EPC STORMWATER REVIEW COMMENTS ARE
SHOWN IN ORANGE BOXES WITH BLACK TEXT

Preliminary & Final Drainage Report
for
The Sanctuary Filing 1
at
Meridian Ranch

**PUDSP2204 &
SF2220**

RESIDENTIAL STREET SECTION
RAMP CURB

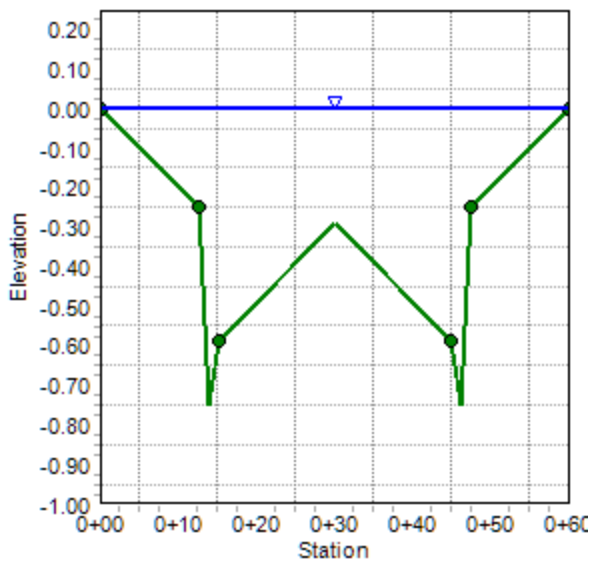
the proposed roads have a 50 ft. ROW. not 60'. Revise accordingly.

RESIDENTIAL STREET SECTION
VERTICAL CURB

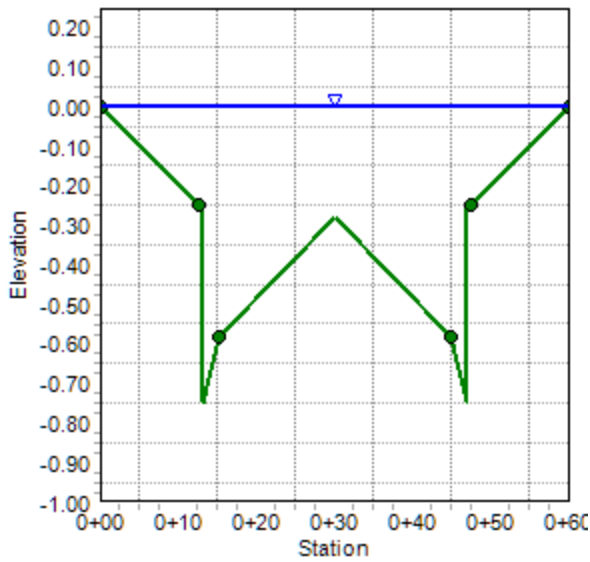
see comment above

FIGURE 7

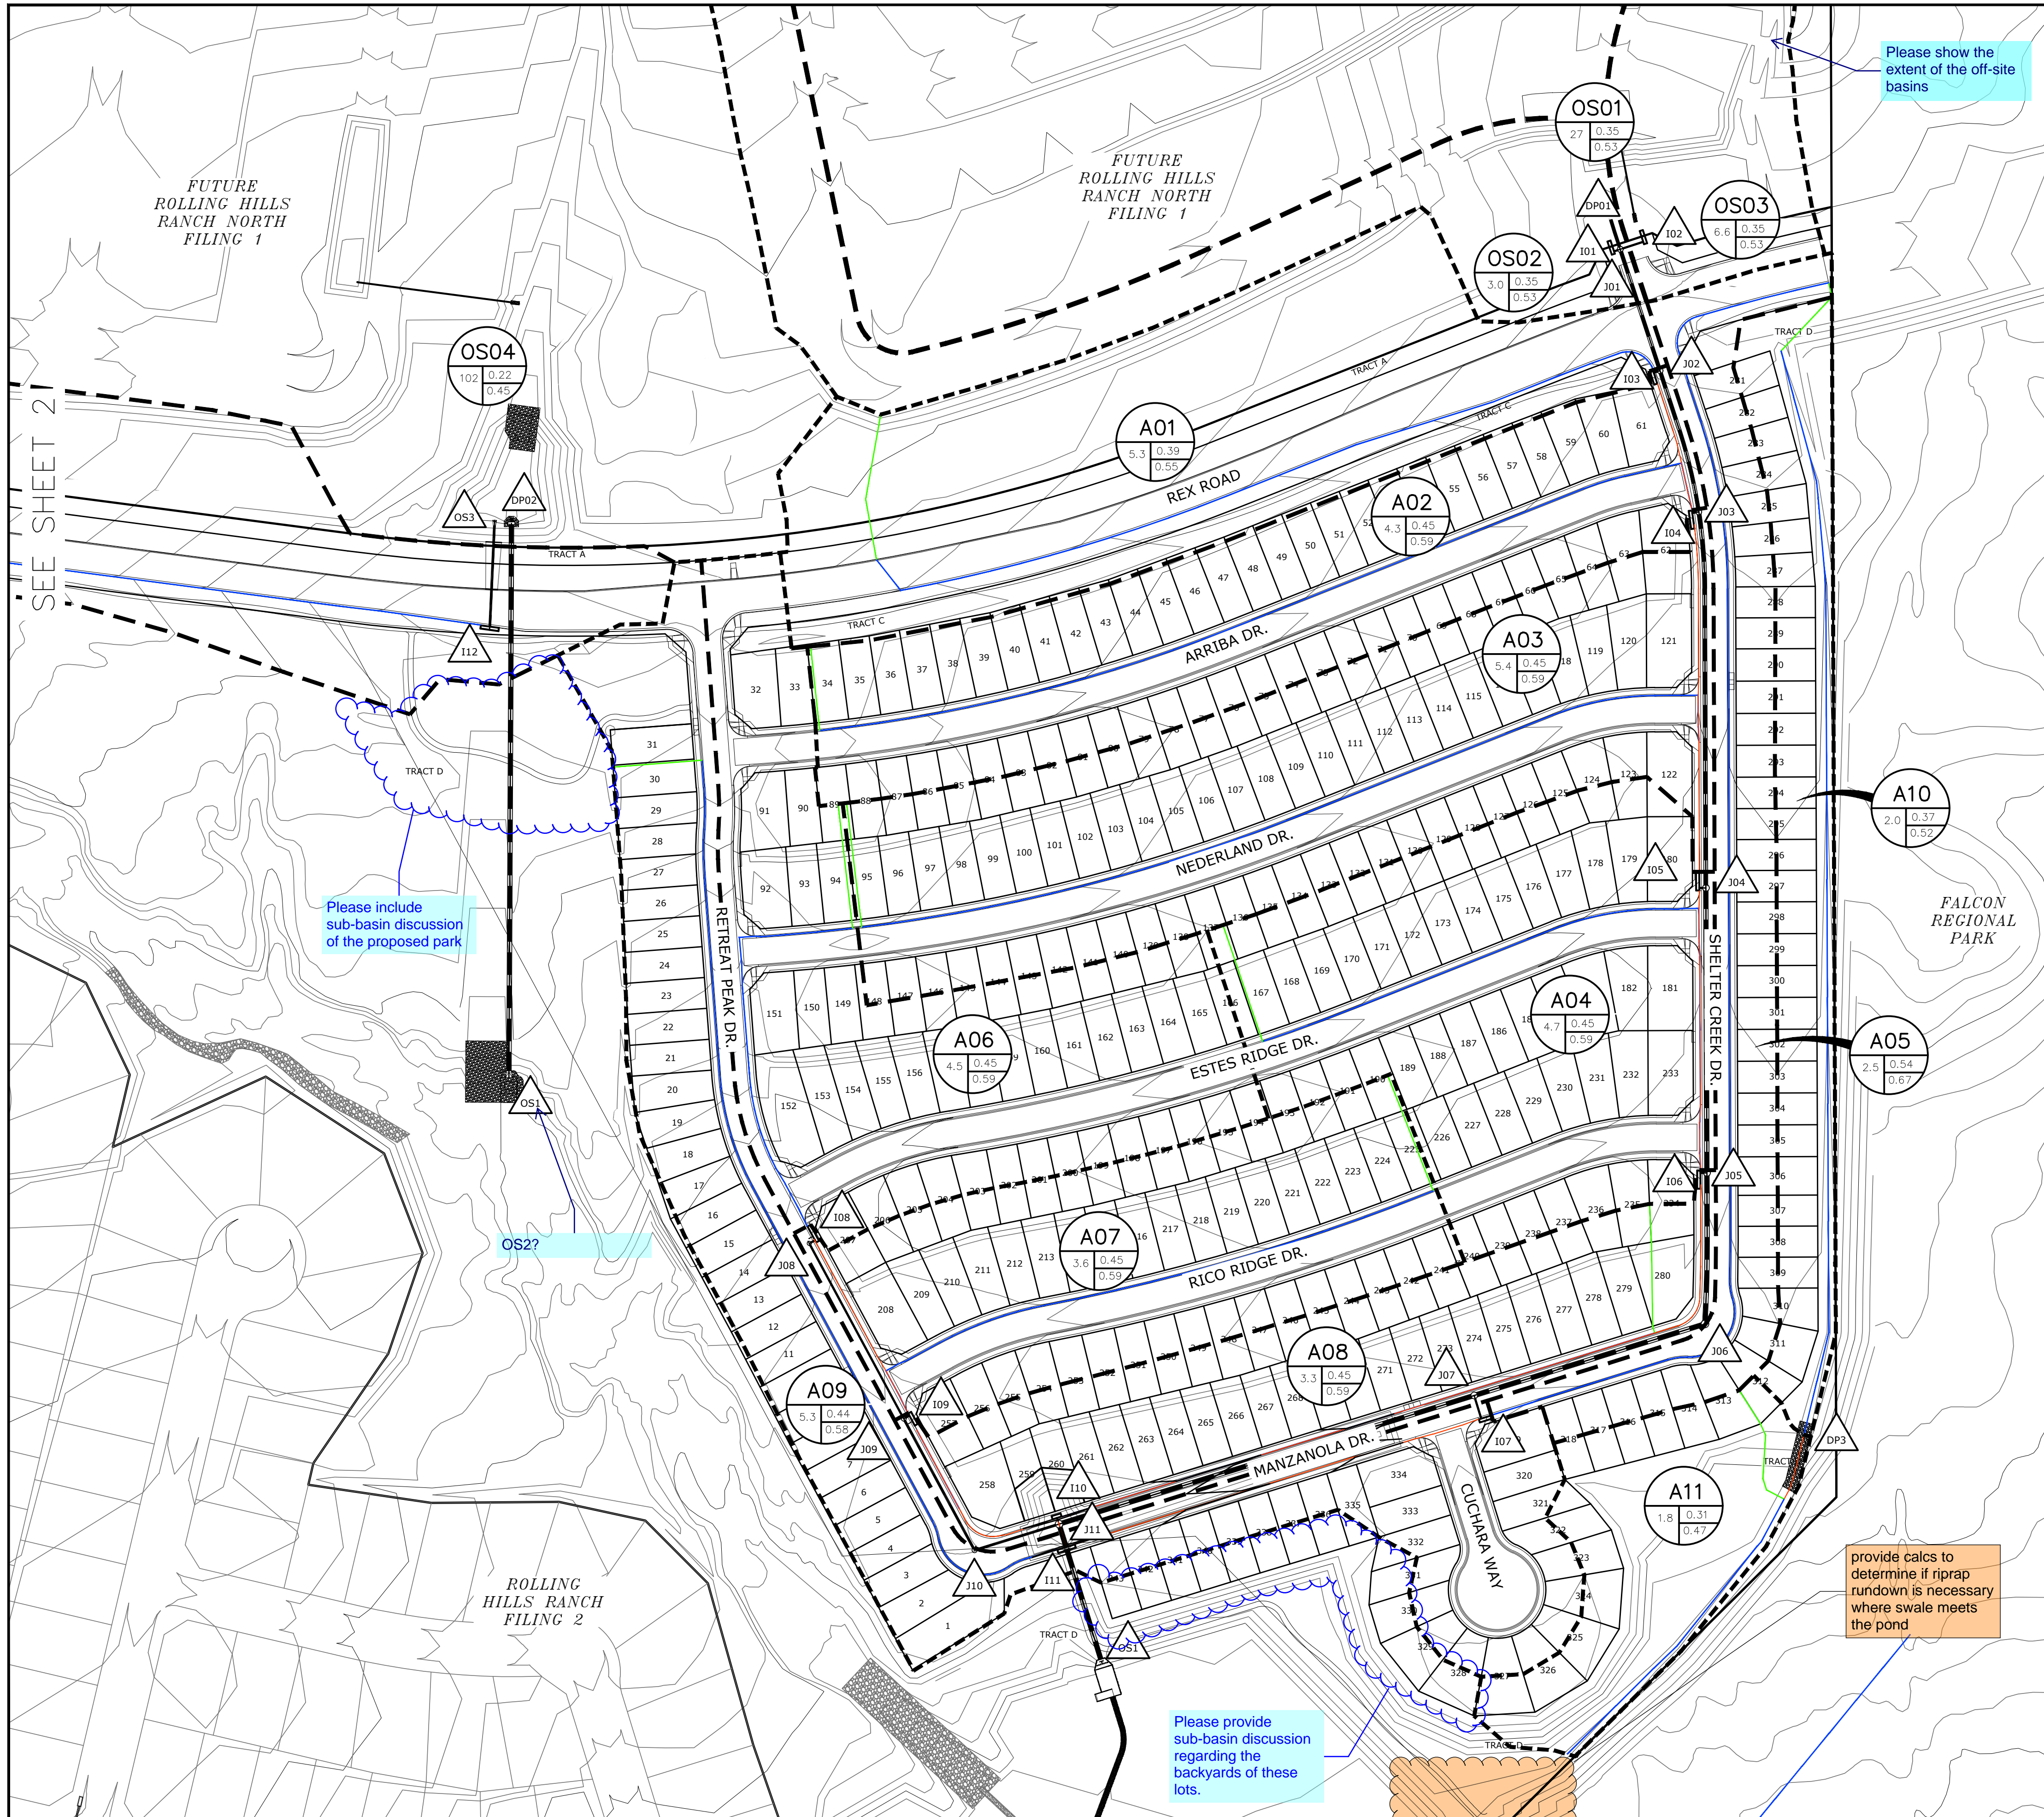
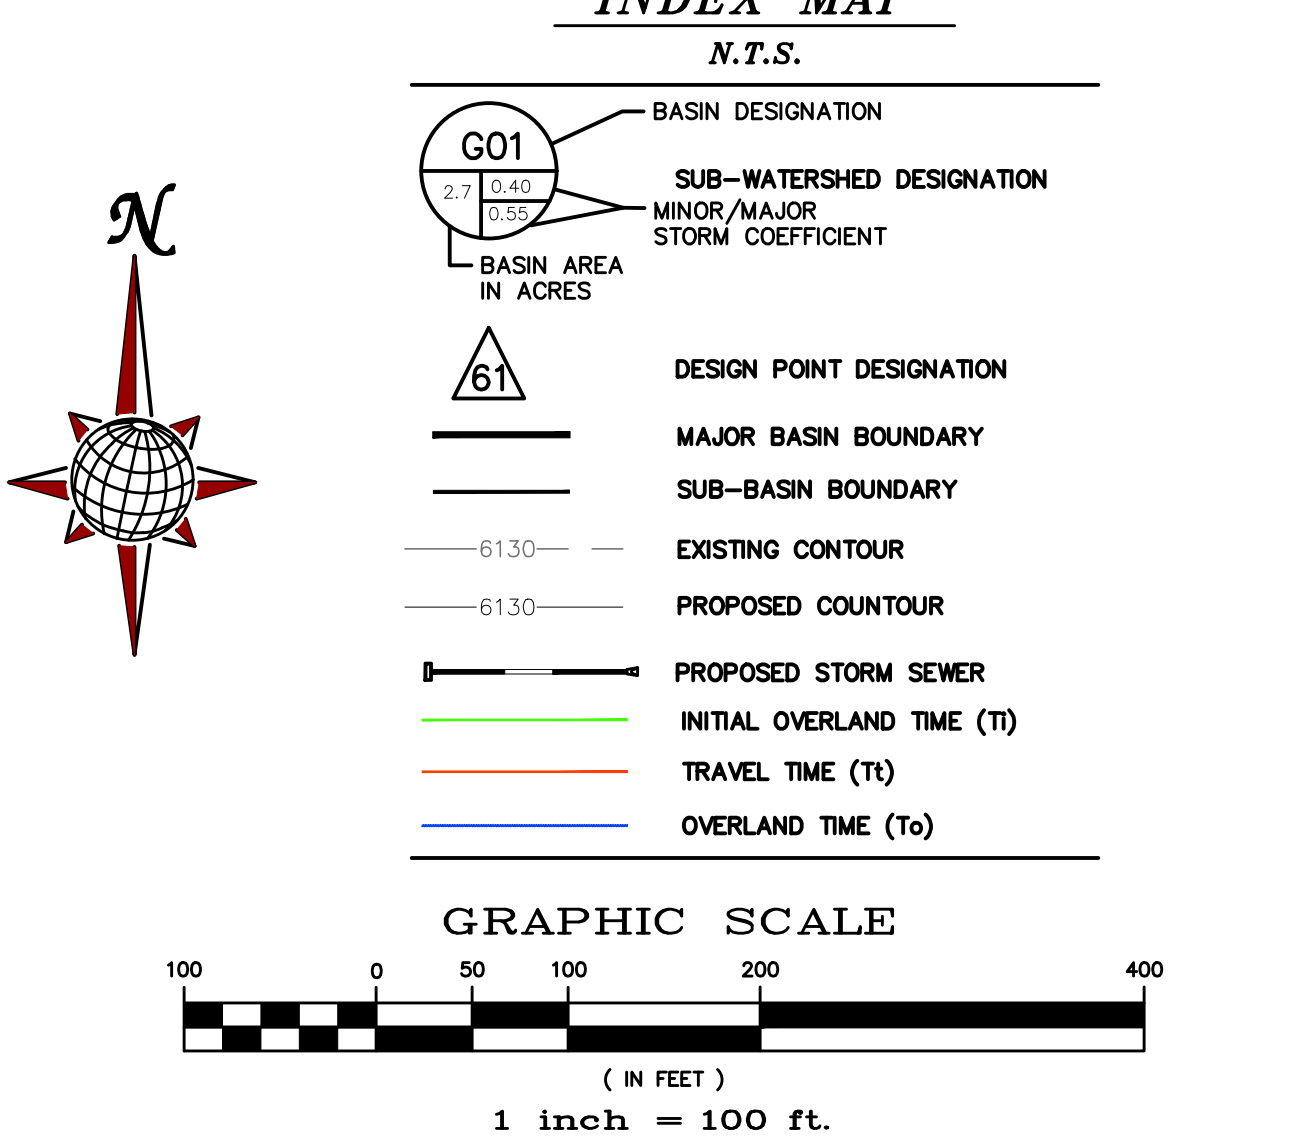
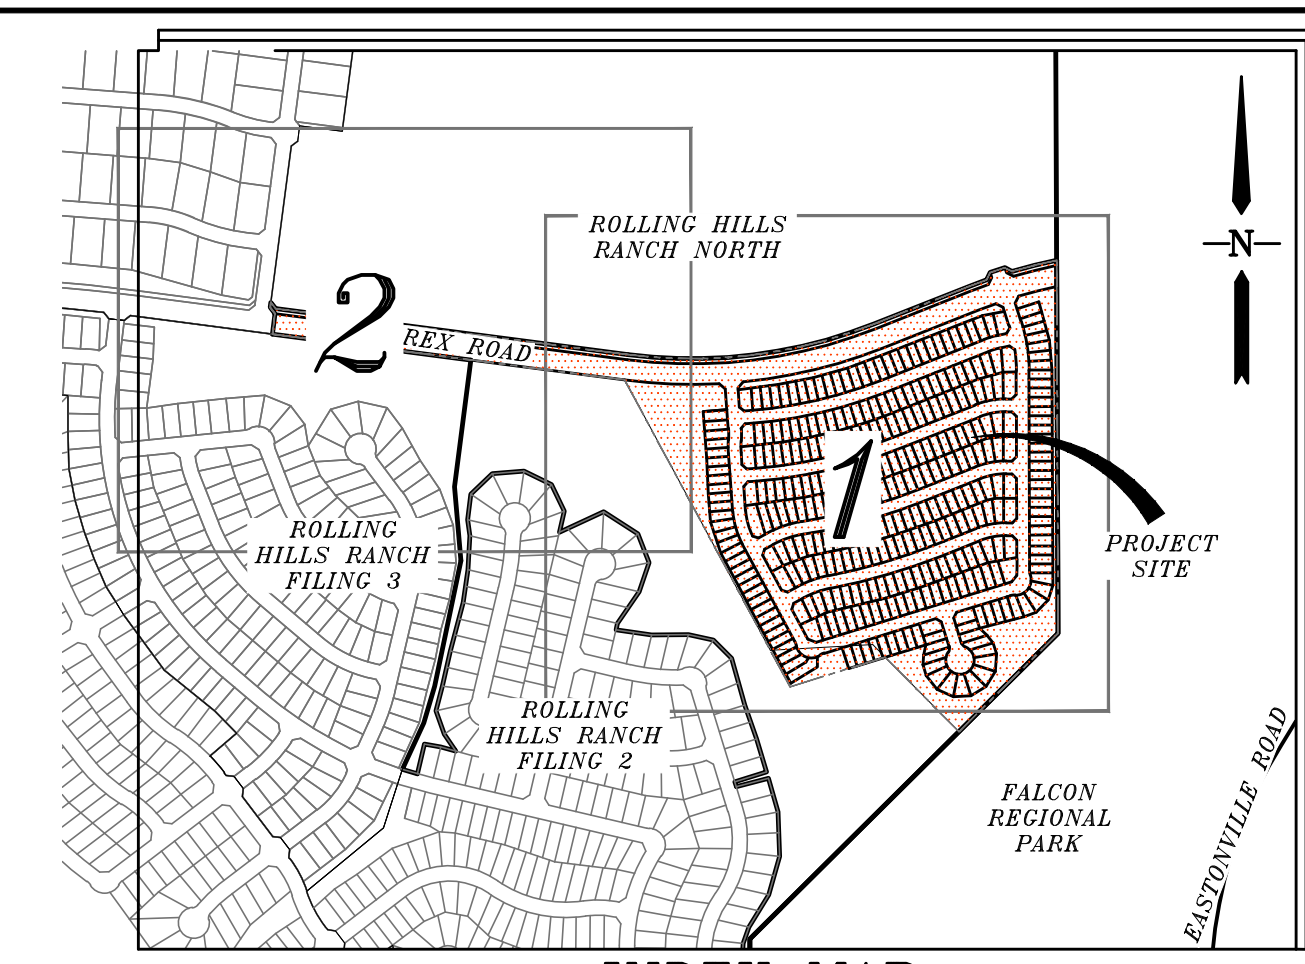
Please show the extent of the off-site basins

Please provide sub-basin discussion regarding the backyards of these lots.

provide calcs to determine if riprap rundown is necessary where swale meets the pond
